St Athan Northern Access Road

FCA Appendix E and F

Welsh Government

February 2017

Figure E8- Flood Depth Difference Map Proposed Culverts vs Baseline, 1% AEP + CC30%

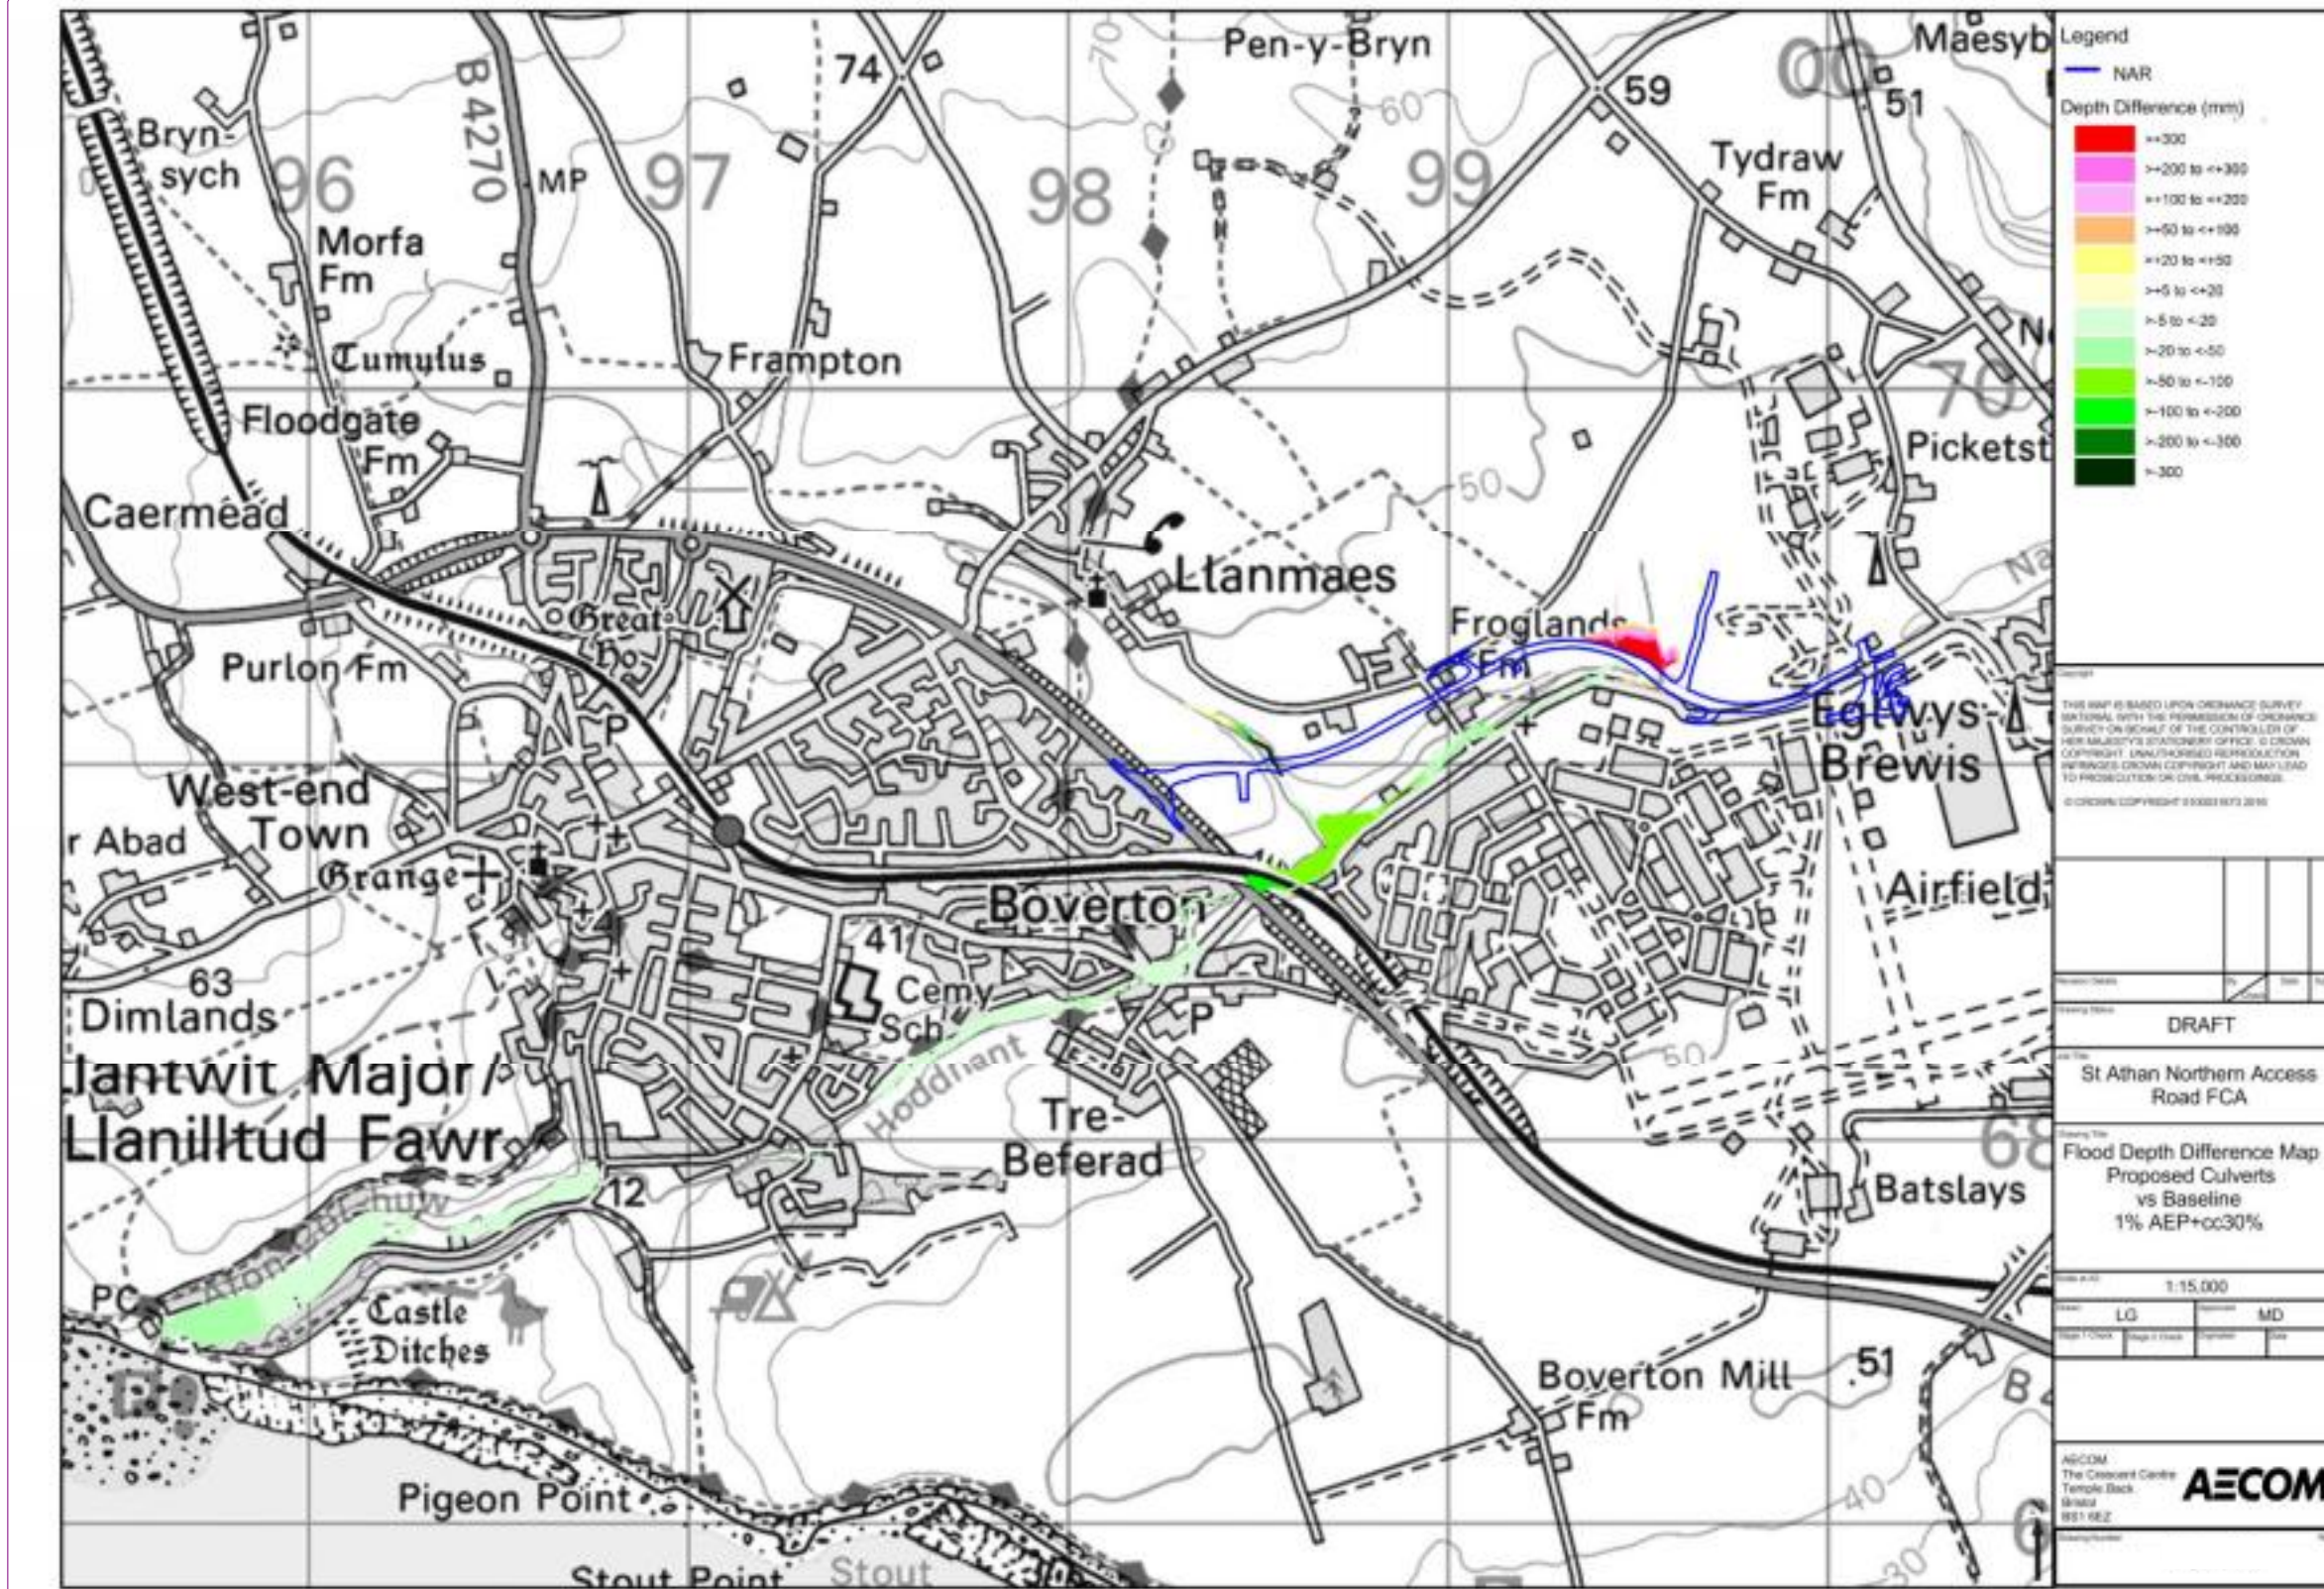
Comment [MD1]: Can we explain why there is no increase in flood depth on llanmaes brook, looks odd?
